Informal document GRSP-56-41
(56th GRSP, 9-12 December 2014,
agenda item 16)

Proposal of amendments to ECE/TRANS/WP.29/GRSP/2014/32

Proposal for Supplement 1 to the 01 series of amendments to Regulation No. 127 (Pedestrian safety)

"Figure 5A

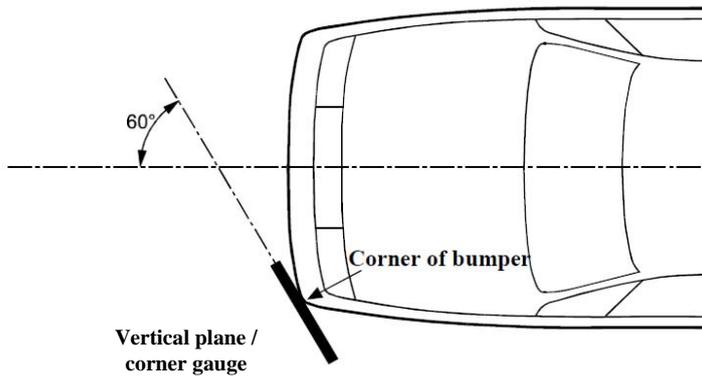
Figure 5, amend to read:

Corner of bumper example (see paragraph 2.17., note that the corner gauge is to be moved in vertical and horizontal directions to enable contact with the outer contour/
~~front fascia of the vehicle~~)

Figure 5B
Corner gauge

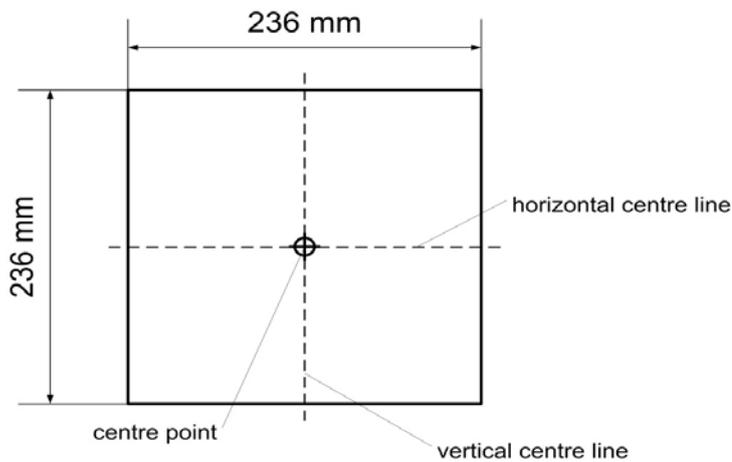
The front surface of the corner gauge is flat.

The centre point is the intersection of the vertical and horizontal centre lines on the front surface.

Figure 5C
Determination of the corner of bumper with the corner gauge (shown in random location)

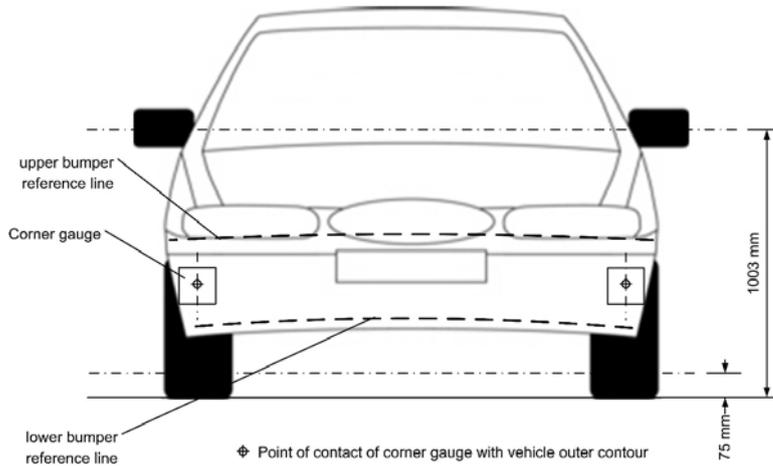
For determination of the corner of bumper, the front surface of the corner gauge is moved parallel to a vertical plane with an angle of 60° to the vertical longitudinal centre plane of the vehicle (see Figures 5A and 5C) at any height of the centre point of the corner gauge between:
